City of Portland, Maine – Building or Use Permit Application 389 Congress Street, 04101, Tel: (207) 874-8703, FAX: 874-8716

BUILDING PERMIT REPORT

DATE: 22 June 99 ADDRESS: 428-430 Woodford ST. CBL: 126-F-008
 REASON FOR PERMIT: Reconstruction of 2 story deck
 BUILDING OWNER: Gi Kas
 PERMIT APPLICANT: Ivan Westma
 USE GROUP R-3 BOCA 1996 CONSTRUCTION TYPE 5B

LAND USE - ZONING REPORT

REPLACING OF DECKS

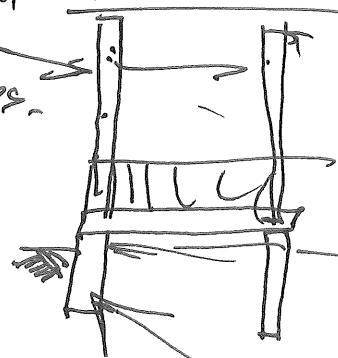
33. Glass and glazing shall meet the requirements of Chapter 24 of the building code.
- X 34. This permit is being issued with the understanding that
The existing Foundation piers are being used-
max. span of 2x6 @ 16"OC, is 9'4"

11. Other requirements of condition There shall be no interconnecting stairways between the 1st floor Deck & the 2nd floor deck. If there is such an interconnecting stairway, separate application with a complete enclosure of the stairways shall be required.
